Re: Seven Hills Townhomes Site Plan – Response to Initial Submittal Review Comments
Application No: DA-2084-01
Case Number: 2017-4017-00

OUTLOOK SEVEN HILLS TOWNHOMES
SITE PLAN
AURORA, CO

SHEET 14 OF 25
L-3

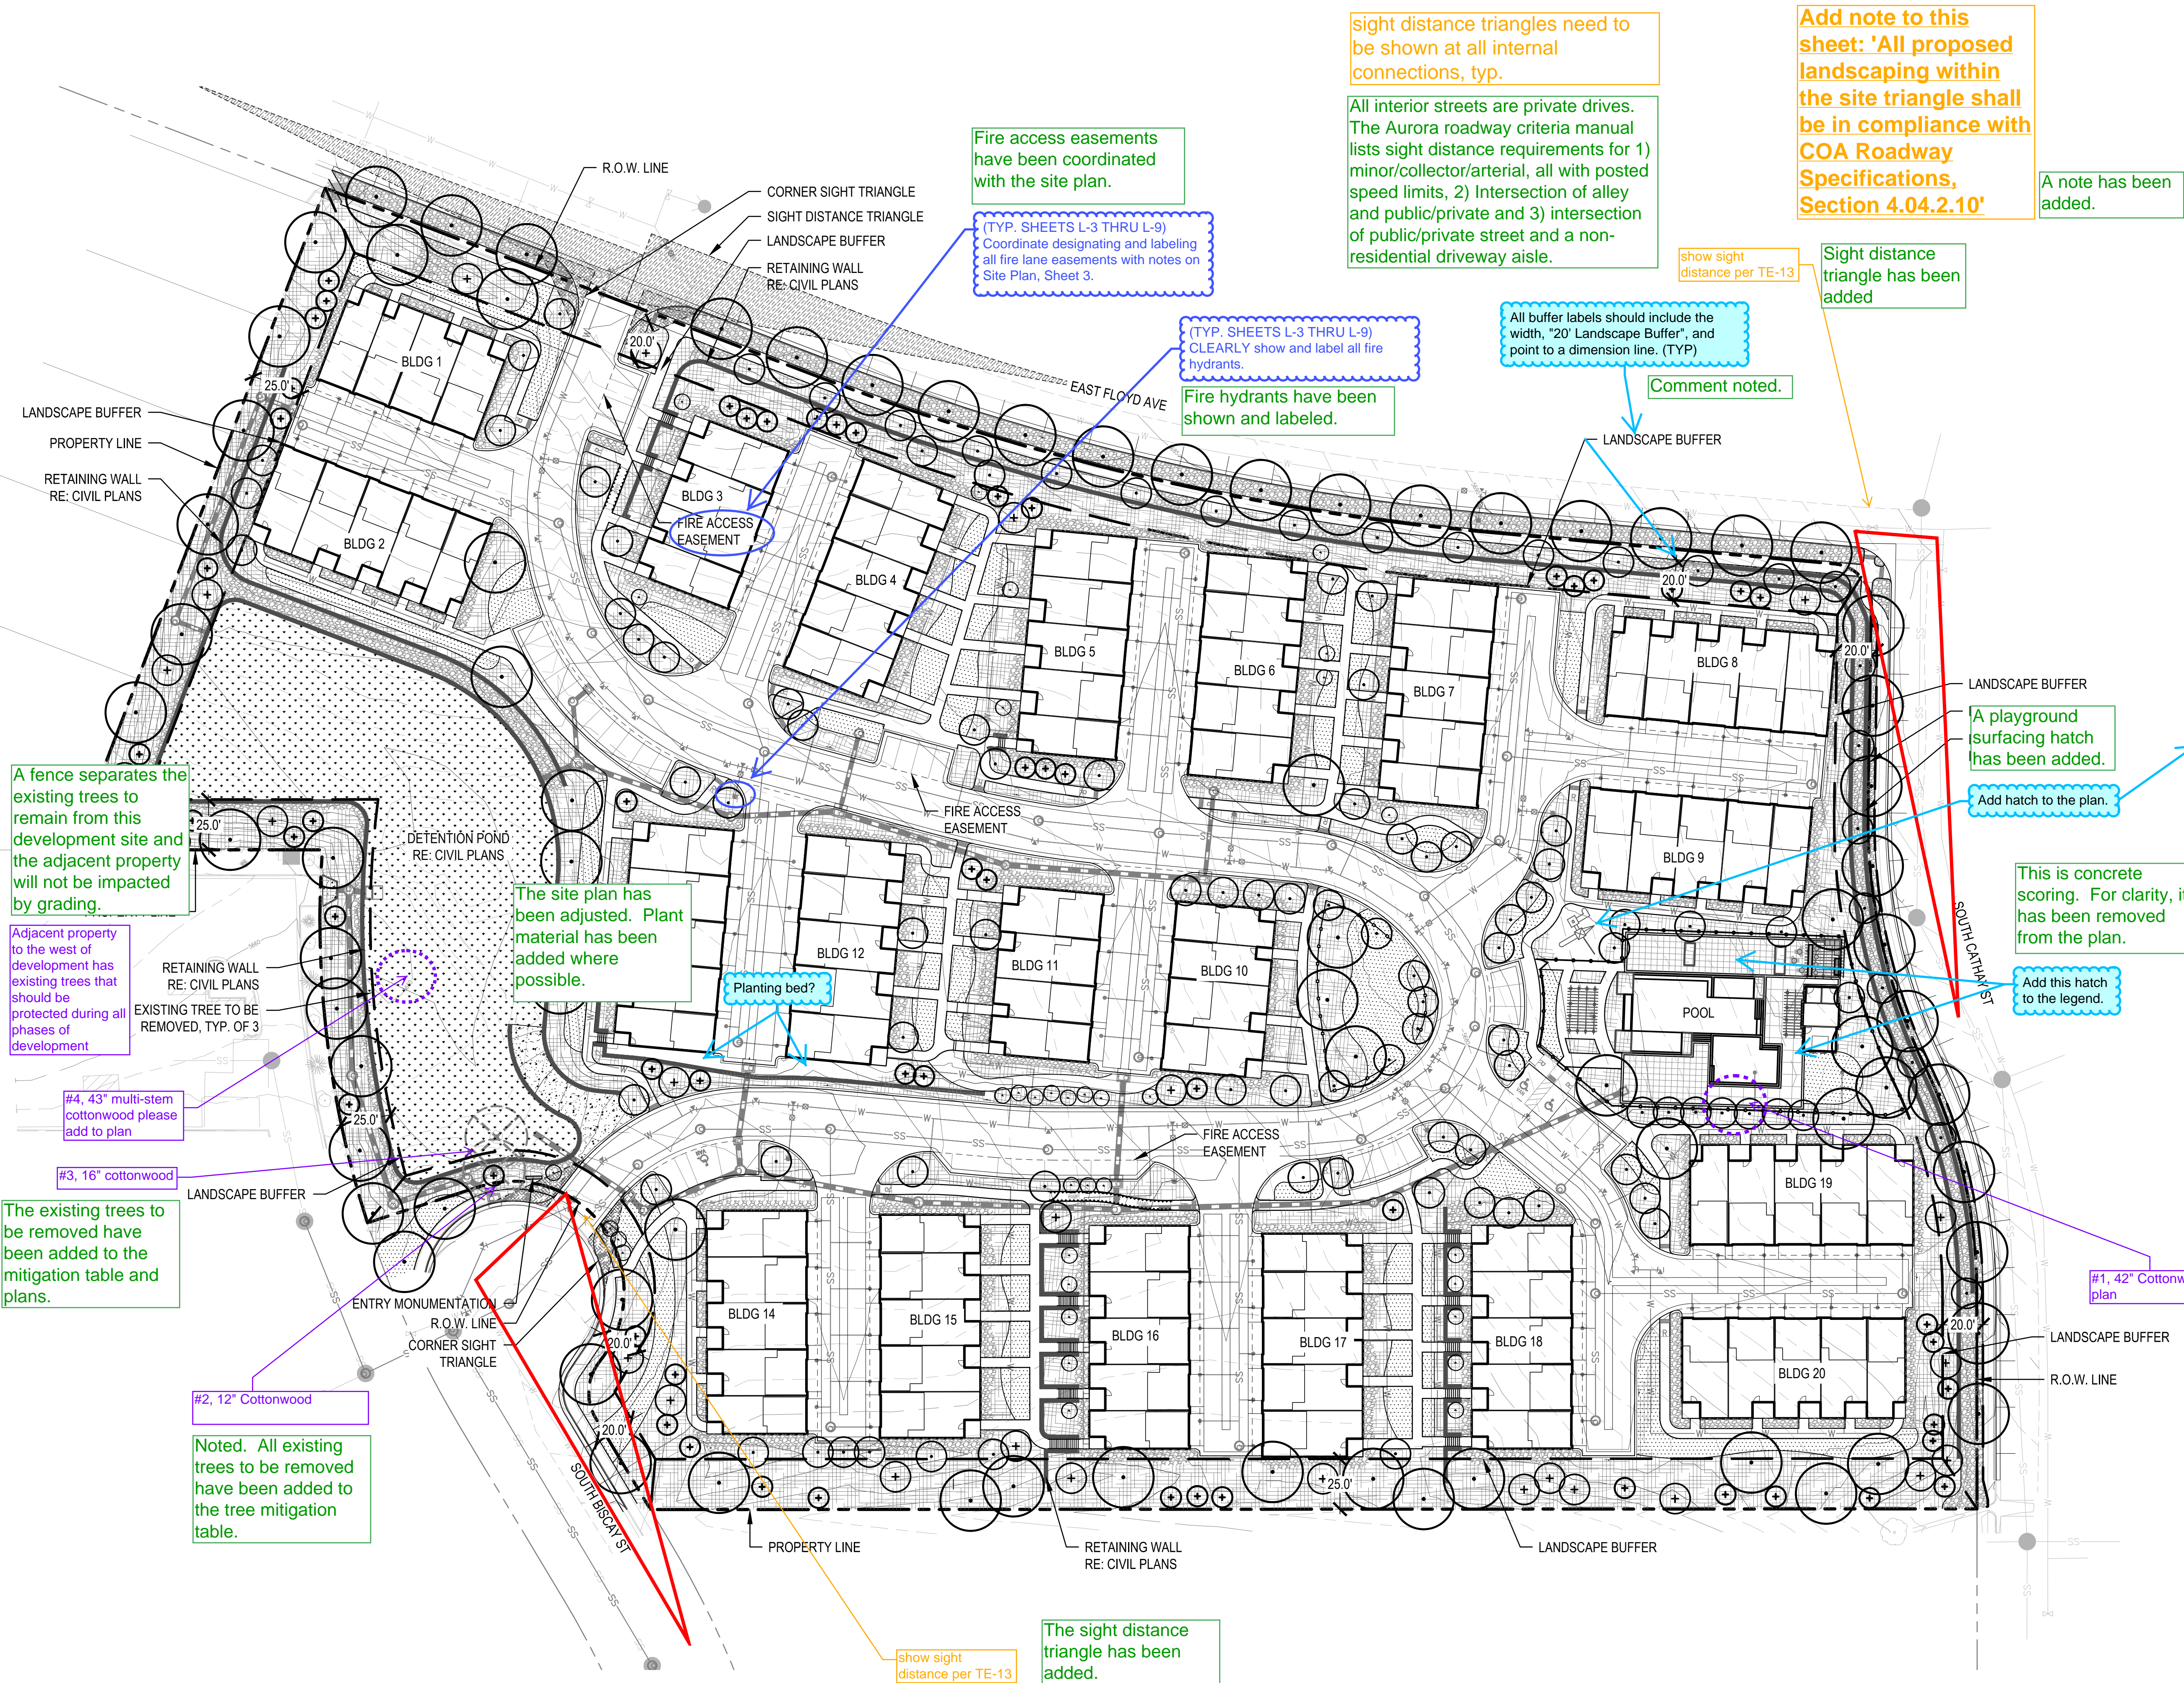
- (TYP. THIS SHEET) Coordinate designating and labeling all fire lane easements with notes on Site Plan, Sheet 3.

- (TYP. SHEETS L-3 THRU L-9)
CLEARLY show and label all fire hydrants.

Response: Fire easement labeling has been coordinated with the site plan.

Response: All fire hydrants have been labeled.

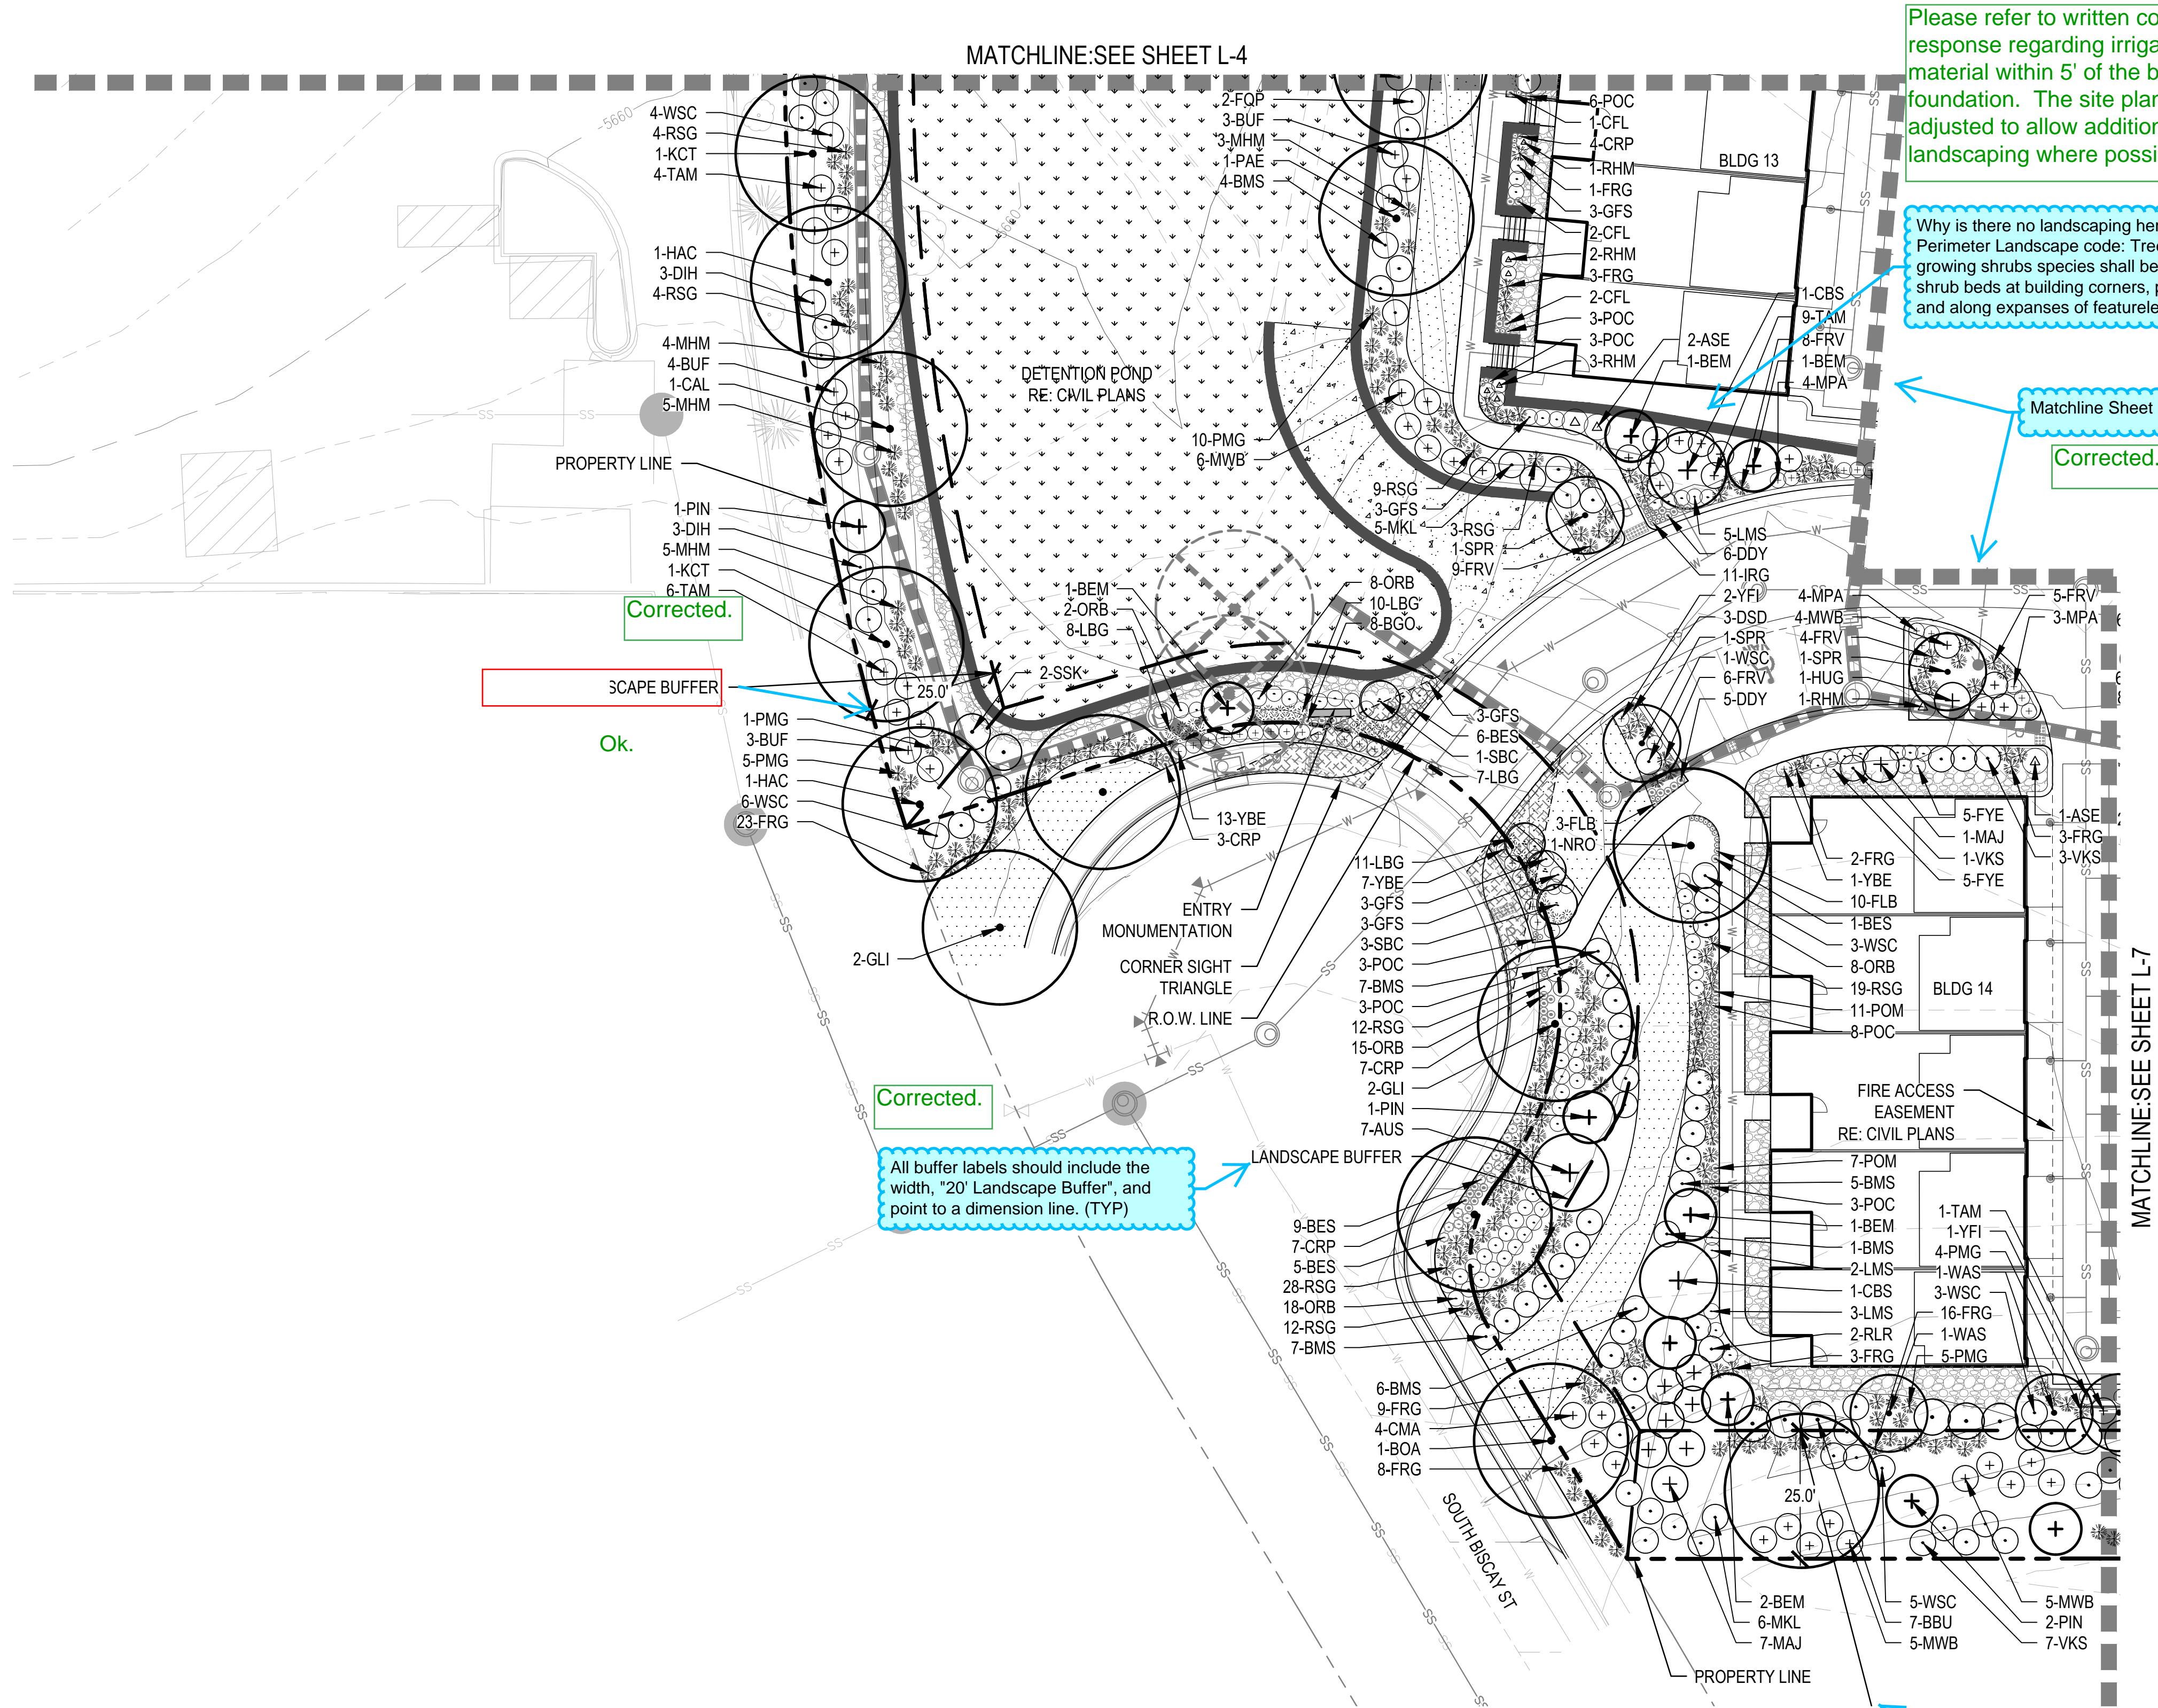
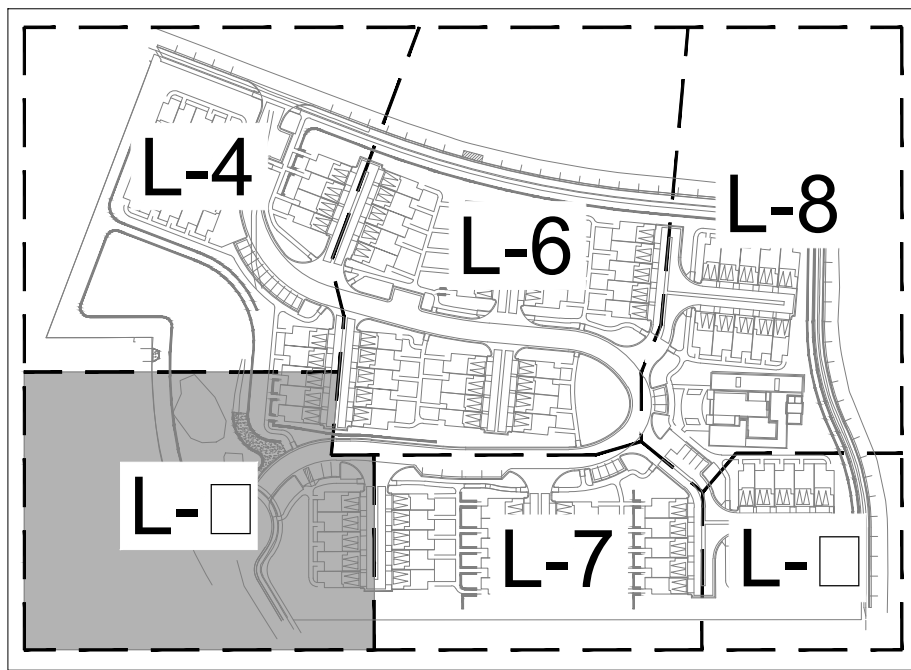
What is this shaded area?

This is an existing utility. The shading has been removed for clarity.

2 POOL FENCE GATE SCALE: 3/4" = 1'-0"

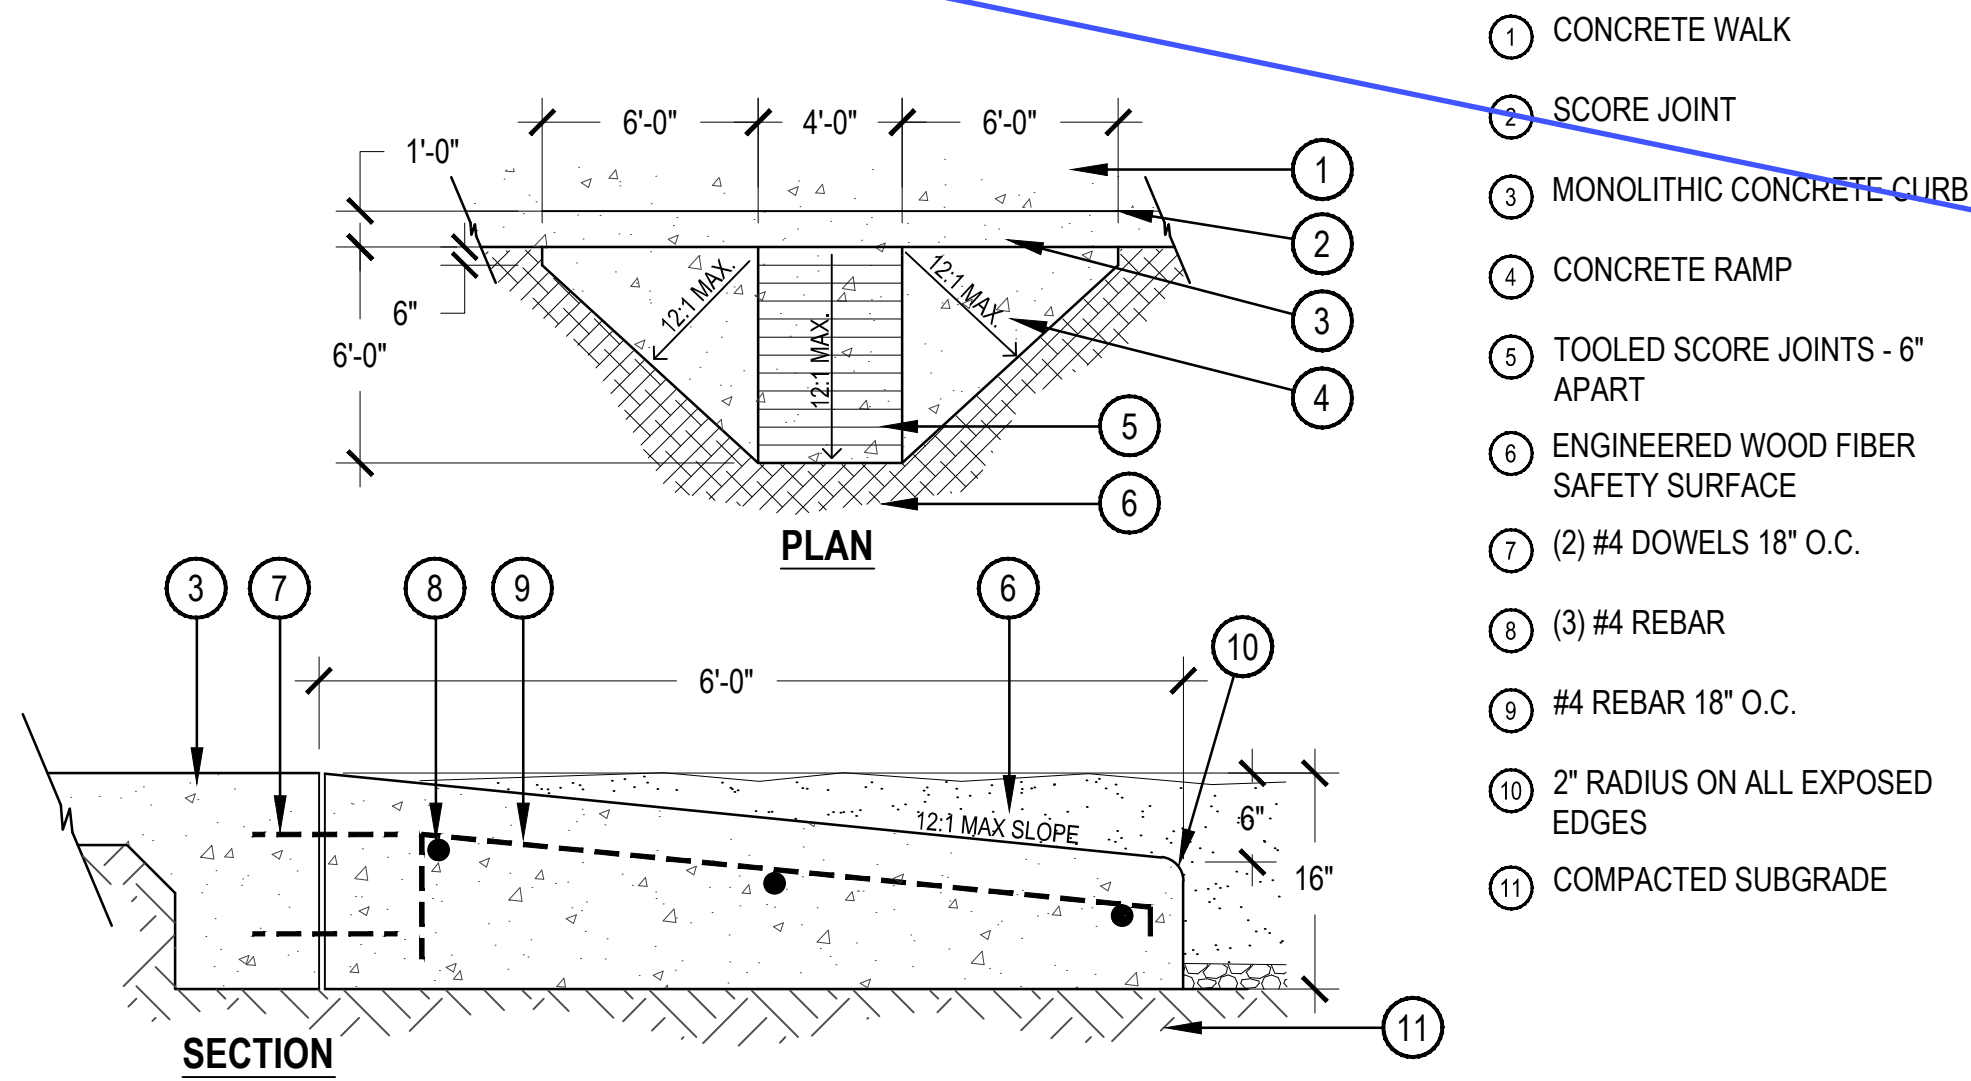
- Re: Detail 2: Provide additional notes:
 - 4' MANWAY GATE WITH KNOX-APPROVED LOCKING DEVICE
 - Provide a placard on the gate reading "GATE TO REMAIN OPEN DURING BUSINESSHOURS".

Provide additional notes:
- 4' MANWAY GATE WITH KNOX-APPROVED LOCKING DEVICE
- Provide a placard on the gate reading "GATE TO REMAIN OPEN DURING BUSINESS HOURS".
Provide note that "ANY LOCKING DEVICE SHALL BE INSTALLED AS A 'KNOX-APPROVED LOCKING DEVICE'."

Response: The additional notes have been added.
